# CITY OF ALBUQUERQUE

**Re: Las Ventanas at San Isidro  
3739 San Isidro NW  
Request Permanent C.O. - Accepted  
Engineer's Stamp Dated 3-23-13 (File: G13D031)  
Certification dated: 7-29-16**

ENGINEER'S SEAL  DAVID SOULE P.E. #14522	LOT 10B1 AND LOT B2 CANDELARIA PLAZA ADDITION	DRAWN BY JDG
	GRADING AND DRAINAGE PLAN	DATE 03-23-06
 1606 CENTRAL AVENUE SE SUITE 201 ALBUQUERQUE, NM 87106 (505) 872-0999		SHEET # 1 OF 1
		JOB #

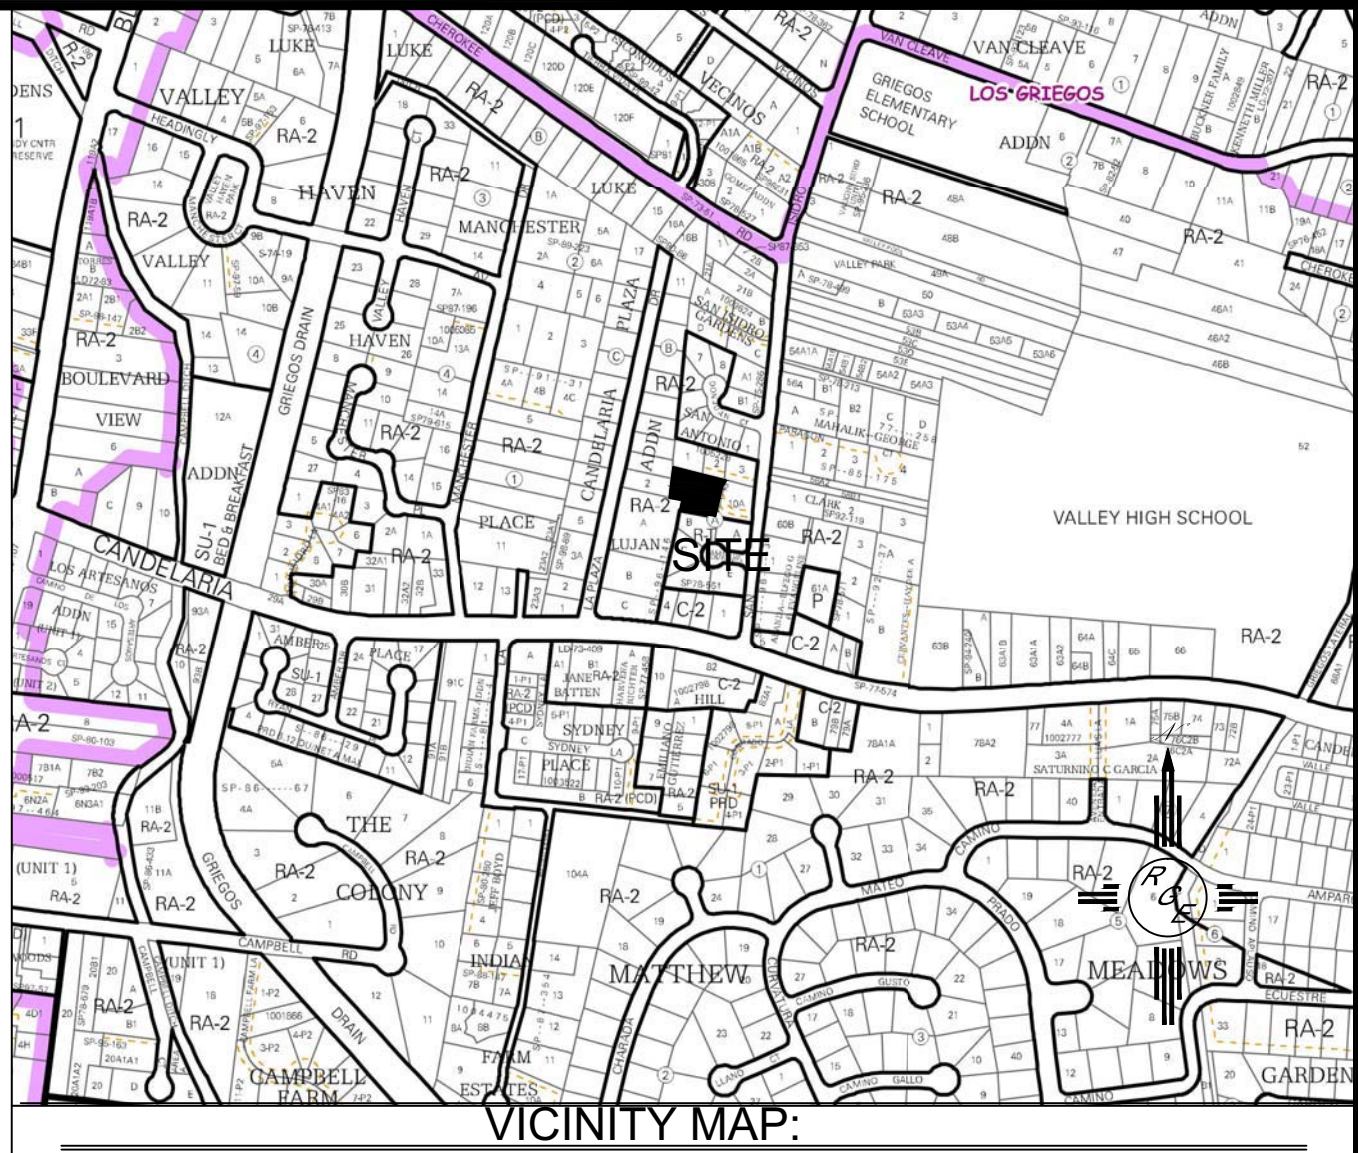
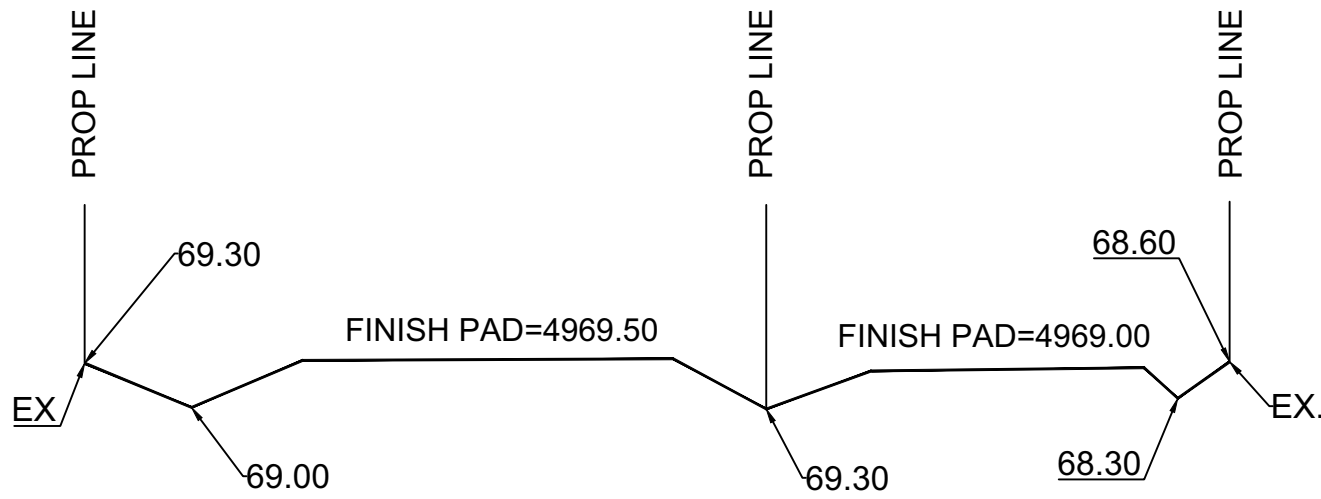
- Both ponds are present however neither is landscaped. During the landscaping phase the integrity of the ponds must be maintained per the City of Albuquerque drainage ordinance.
- The ponds must be stabilized with landscaping within 90 days from the date of this letter.
